Access Compliance Report Public Rights-of-Way (Curb Ramps)

Intersection ID: 11698 Main Street: S CEDAR ST Cross Street: W_4TH_ST Location:

Overall Compliance: No ADA ID: D268F5773385 Ramp Type: PerpDiag Initial Pass/Fail: Fail Severity Score: 13.75

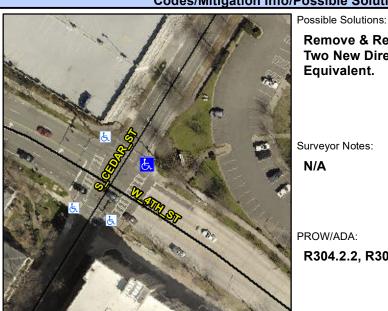
R304.2.2, R304.5.3

Compliance Description I		Data	Compliance Description		Data
N/A	Ramp Length (in)	64.0	No	Ramp Slope (%)	9.1
Yes	Ramp Width (in)	58.0	No	Ramp XSlope (%)	3.8
N/A	Flare Type LT	N/A	N/A	Flare Type RT	N/A
N/A	Flare Slope LT (%)	N/A	N/A	Flare Slope RT (%)	N/A
N/A	Flare Traversable LT?	N/A	N/A	Flare Traversable RT?	N/A
N/A	Landing Length (in)	N/A	N/A	DWS Provided?	N/A
N/A	Landing Width (in)	N/A	N/A	DWS Contrast?	N/A
N/A	Landing Slope (%)	N/A	N/A	DWS Length (in)	N/A
N/A	Landing X Slope (%)	N/A	N/A	DWS Full Width?	N/A
N/A	Landing Curb? (Y/N)	N/A	N/A	DWS Offset (in)	N/A
N/A	Shared Landing?	N/A			
N/A	Gutter Ponding?	N/A	N/A	Gutter Slope (%)	N/A
N/A	Gutter Lip Ht (in)	N/A	N/A	Gutter X Slope (%)	N/A
N/A	Painted X Walk1?	Yes	N/A	Painted X Walk2?	Yes
	X Walk 1 Direction	To NW		X Walk 2 Direction	To SW
N/A	X Walk 1 Width (in)	110.0	N/A	X Walk 2 Width (in)	109.0
	X Walk 1 Slope (%)	1.0		X Walk 2 Slope (%)	0.4
	X Walk 1 X Slope (%)	1.3		X Walk 2 X Slope (%)	1.2

Remove & Replace Curb Ramp With Two New Directional Ramps or Equivalent.
